GENERAL INFORMATION

Applicant:	Bloomington Central Station LLC c/o McGough Development
Location:	8170 31 st Avenue South
Request:	Preliminary and Final Plat for Bloomington Central Station 5 th Addition; Major Revision to Final Development Plan for a 1,657 stall parking structure and surface parking improvements.
Existing Land Use and Zoning:	Vacant commercial land; zoned High Intensity Mixed Use with Residential (Planned Development) – HX-R (PD) and Airport Runway – AR-17
Surrounding Land Use and Zoning:	North – Park, surface parking and light rail transit right-of-way; zoned HX-R (PD) South – Office and vacant land; zoned C-4 East – Multiple-family dwelling; zoned HX-R (PD) West – Structure parking ramp, office and manufacturing; zoned LX and CO-1
Comprehensive Plan Designation:	South Loop Mixed Use

Project Description: Type II Preliminary and Final Plat to divide one outlot into one lot and three outlots; Major Revision to Final Development Plans for a new 8-level parking structure plus loading dock and surface parking modifications. Airport Zoning Permit.

Exhibit 1: Parking Areas for BCS – Health Partners

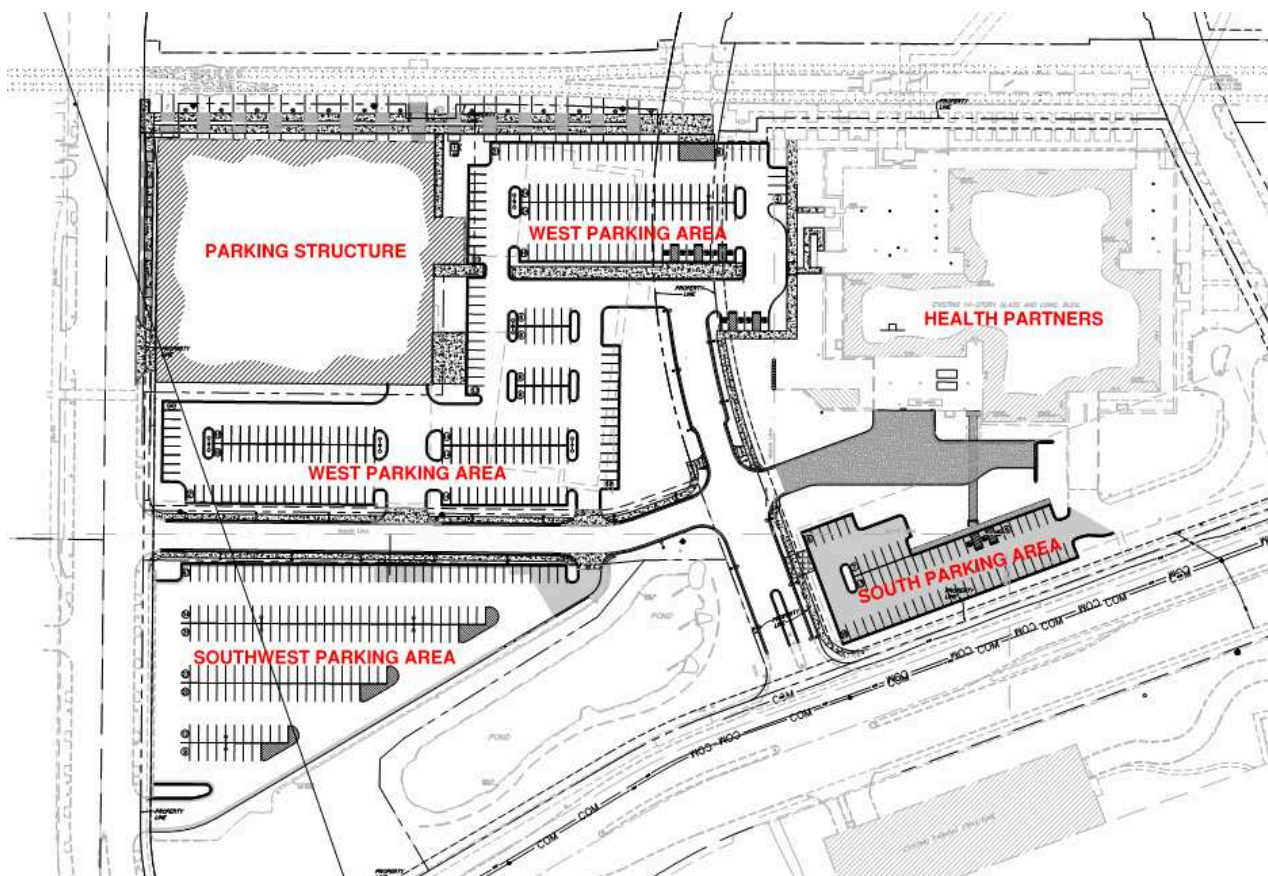
Along with the parking structure, there are three areas of surface parking proposed. See Exhibit 1 for a map identifying the surface parking areas discussed in this report. Each specific surface parking area is proposed to be modified in some fashion from its existing condition.

In addition to parking counts, a summary of improvements to the three surface parking areas is also warranted. Code-compliant landscaping and lighting is planned for both the South and West parking areas, whereas only Code-compliant lighting is planned for the Southwest parking area. The improvements to the Southwest parking area are considered to be more related to parking lot maintenance than permanent development. The temporary parking lots were approved to be constructed in their current condition while awaiting future development. All of the surface parking areas are intended for more permanent development at some point in the future. Nevertheless, the West and South parking areas will be improved to Code-compliant status for the interim period prior to future development.
